SAXTON NUCLEAR EXPERIMENTAL CORPORATION

DOCKET NO. 50-146  
LICENSE DPR-4

-----  
CHANGE REQUEST NO. 28  
-----

Test Fuel Assembly XVIII

FIGURE 1. SAXTON BURNABLE POISON TEST ASSEMBLY.

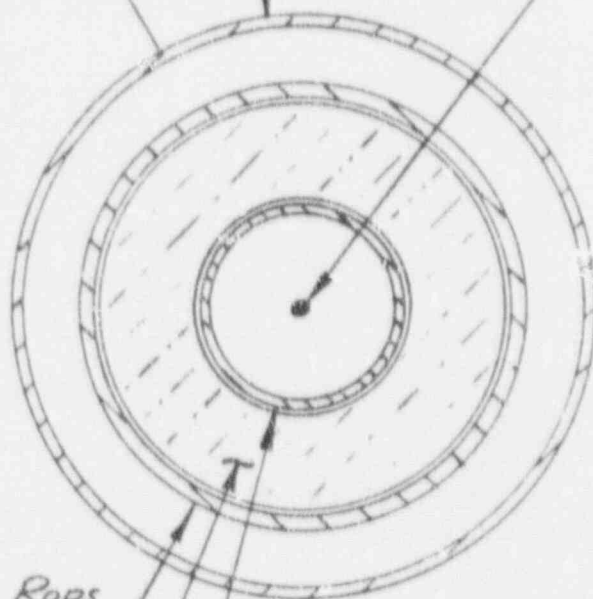
In Supplement No. 1 to Technical Specifications, add the following Test Fuel Assembly to Item F.2.

One 9 rod subassembly of standard pitch and array shall contain the following:

- a. Two burnable poison test rods containing borosilicate (Pyrex) glass tubing (0.388 nom. O.D. x 0.251 nom. I.D.) sealed in type 304 stainless steel clad (0.4315 nom. O.D. x 0.019 nom. wall thickness) will be suspended in a type 304 stainless steel RCC thimble guide tube (0.519 nom. O.D. x 0.4945 nom. I.D.). The borosilicate glass is annular in cross section (Figure 1) and is supported on the inner side by a type 304 stainless steel tube (0.245 nom. O.D. x 0.007 nom. wall thickness). The composition of the borosilicate glass is shown in Table 1. These rods may contain a 0.02 inch diameter Al-Co alloy tracer wire sealed in a 0.035 inch diameter titanium tube suspended in the central void from an attachment to the inner surface of the top end plug.

- b. The four corner positions and the center position of the subassembly contain dummy fuel rods of the same size and configuration as standard Saxton fuel rods, but contain no fuel. The five dummy rods are orificed at the top and bottom end plugs to permit filling of the rod internal volume with primary coolant.

- c. The remaining two rods will be any combination of the following:
  1. Zircaloy-4 clad rods containing Zircaloy-4 encapsulated stress relaxation test specimens described in Change Request No. 74.

2. Internally pressurized Zircaloy-4 clad rods containing 17.4% enriched  $\text{UO}_2$  fuel pellets described in Change Request No. 22.
  3. Internally pressurized 304 SST clad rods containing 5.7% enriched  $\text{UO}_2$  fuel pellets described in Change Request No. 22.

The test subassembly may be located in one of two peripheral core positions, either the N-3 position or the N-5 position. When the subassembly contains 17.4% enriched fuel rods it may be operated at reactor power levels up to 23.5 MWt, otherwise it may be operated at power levels up to 35 MWt.
